Access Compliance Report Public Rights-of-Way (Curb Ramps)

Main Street: SHAKESPEARE_DR Cross Street: DONOVAN_RD Location: S

ADA ID: RPAT211202094901 Ramp Type: Type 1 - Perpendicular Diagonal Initial Pass/Fail: Pass Overall Compliance: No Severity Score: 21

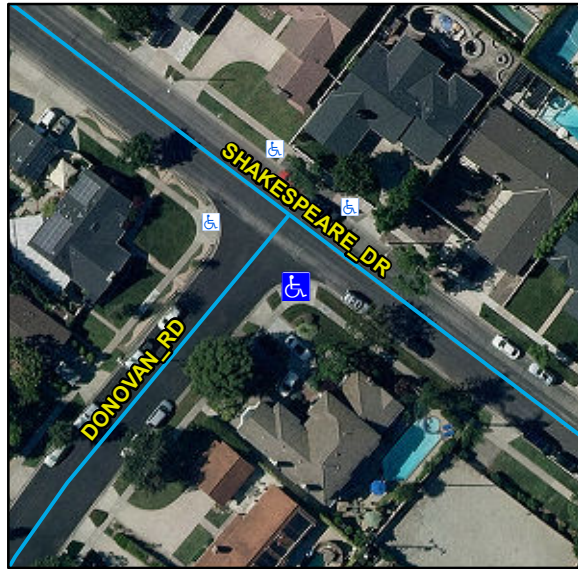
Compliance	Description	Data	Compliance	Description	Data
N/A	Ramp Length (in)	87	N/A	Flare Type LT	
Yes	Ramp Width (in)	48			Sloped
Yes	Ramp Run Slope (%)	6.8	N/A	Flare Slope LT (%)	8.1
Yes	Ramp Cross Slope (%)	0.4	N/A	Flare Traversable LT	No
N/A	Landing Present	Yes	N/A	Flare Type RT	
N/A	Landing Length (in)	30			Sloped
Yes	Landing Width (in)	60	N/A	Flare Slope RT (%)	4.1
Yes	Landing Run Slope (%)	1.3	N/A	Flare Traversable RT	No
Yes	Landing Cross Slope (%)	1.4	No	DWS Provided	No
N/A	Landing Movement Obstructed?	No	N/A	DWS Contrast	N/A
	Landing Movement Type	N/A	N/A	DWS Length (in)	N/A
N/A	Landing Shared	No	N/A	DWS Full Width	N/A
N/A	Clear Space	Yes	N/A	DWS Offset Left (in)	N/A
N/A	Clear Space To Crosswalk (in)	48	N/A	DWS Offset Right (in)	N/A
N/A	Marked Crosswalk 1	No	N/A	Marked Crosswalk 2	No
	Crossing 1 Direction	NE		Crossing 2 Direction	NW
	Marked Crosswalk 1 Width (in)	N/A		Marked Crosswalk 2 Width (in)	N/A

N/A	Ramp Inside Crosswalk 1	N/A	Yes	Ramp Inside Crosswalk 2	N/A
	Crossing 1 Slope (%)	4.3		Crossing 2 Slope (%)	3.3
	Crossing 1 Cross Slope (%)	0.9		Crossing 2 Cross Slope (%)	2.6
Yes	Gutter Ponding	No	No	Curb Slope	8.7
Yes	Gutter Lip Height (in)	0		Road Run Slope (%)	2.4
No	Gutter Run Slope (%)	7.2		Road Cross Slope (%)	3.4
Yes	Gutter Cross Slope (%)	1			
Yes	Overall Surface Condition: Acceptable		No	Perp Joint Present	No
	Cross Gutter Present?	No		Spandrel Present?	No
	Replace Cross Gutter?	N/A		Replace Spandrel?	N/A

Remove & Replace Curb Ramp With Two New Directional Ramps or Equivalent. Remove & Replace Gutter.
